PLAN REVIEW SHEET

Telephone: 704-353-0018 **Petition:** 2013-032

The Housing Partnership

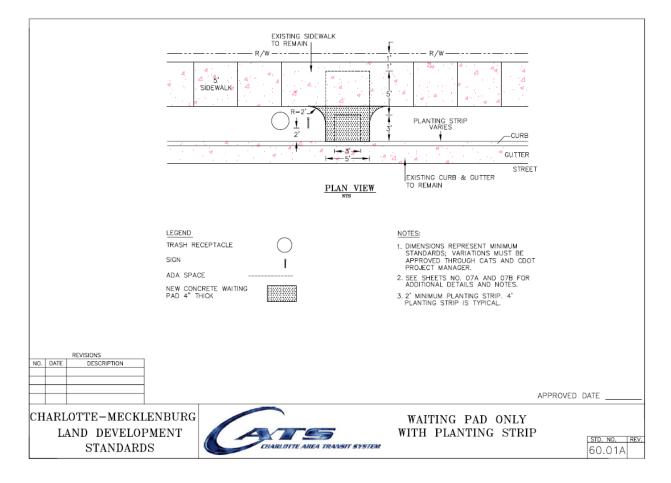
We request that the Petitioner provide a waiting pad for restored bus service along Double Oaks Road.

The size and specification of the concrete waiting pad at the bus stop would be located between the existing curb and the existing sidewalk and be 5 feet in width. Pad must be flush with sidewalk and level within 2% when measured perpendicular to street for compliance with the ADA. Below is an image of the standard (CLDSM – 60.01A) waiting pad.
